Memorandum

Subject: Weaknesses in the Entergy Study of the Reliability Impacts of Closing Indian Point Units 2 and 3.

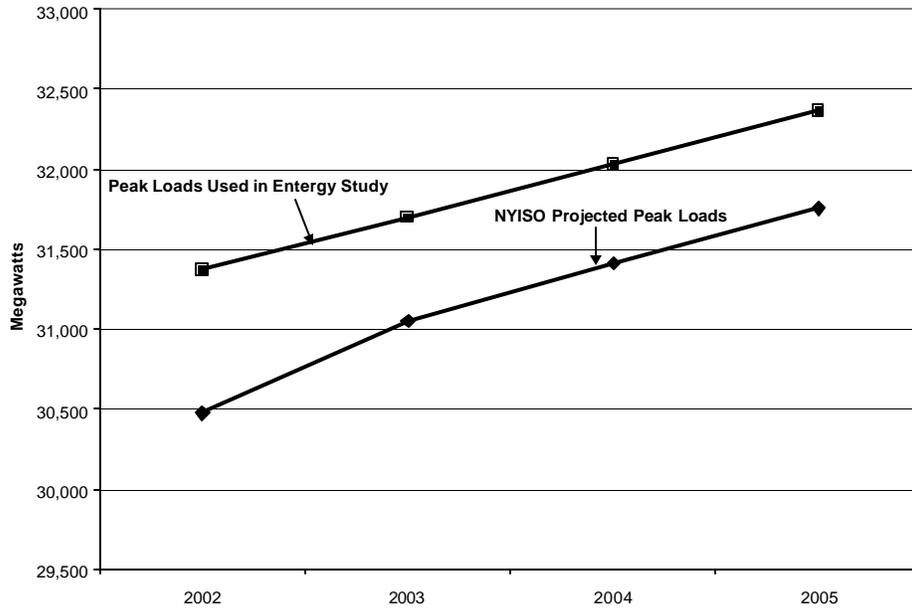
The following figure compares the peak loads assumed for the years 2002 through 2005 in the Entergy study with the peak loads for the same years projected by the New York Independent System Operator (“NYISO”) in its recent March 2002 report, “Power Alert II, New York’s Persisting Energy Crisis.” As you can see, the peak loads assumed in the Entergy study are significantly higher than the peak loads projected by the NYISO.

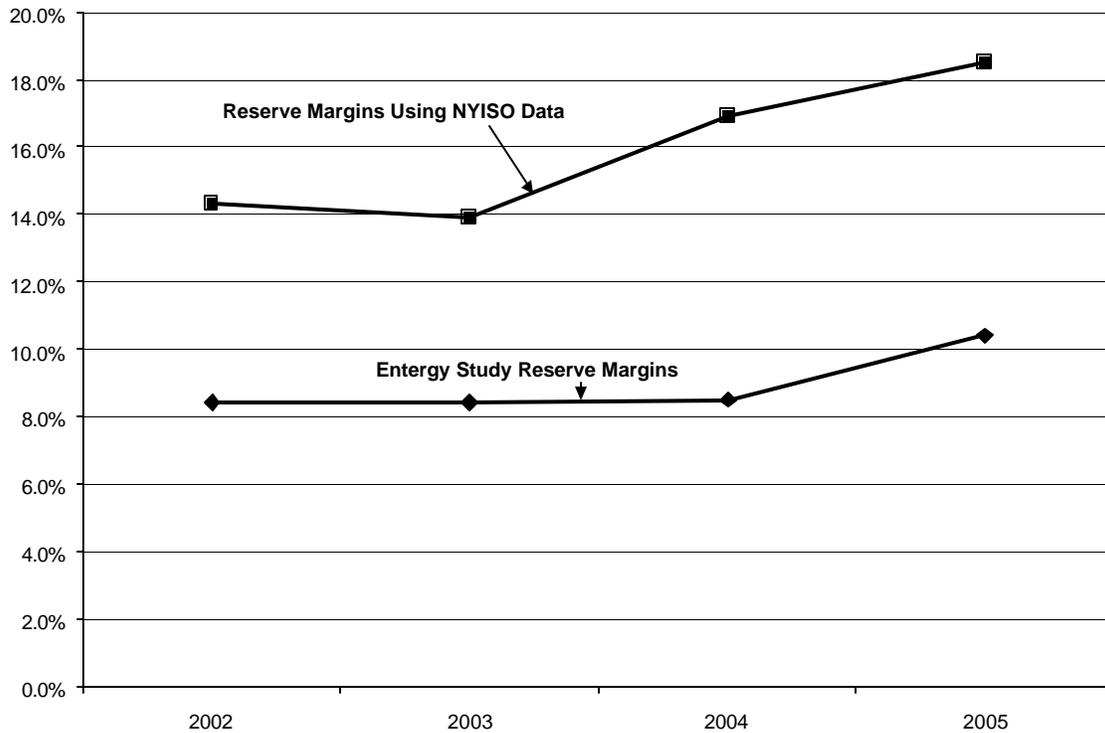
The following figure compares the system reserve margins that Entergy claims would exist in New York State if Indian Point were closed with the reserve margins calculated in the table above. As can be seen, using NYISO projected peak demands and installed capacity results in significantly higher projected reserve margins for each of the years 2002 through 2005.
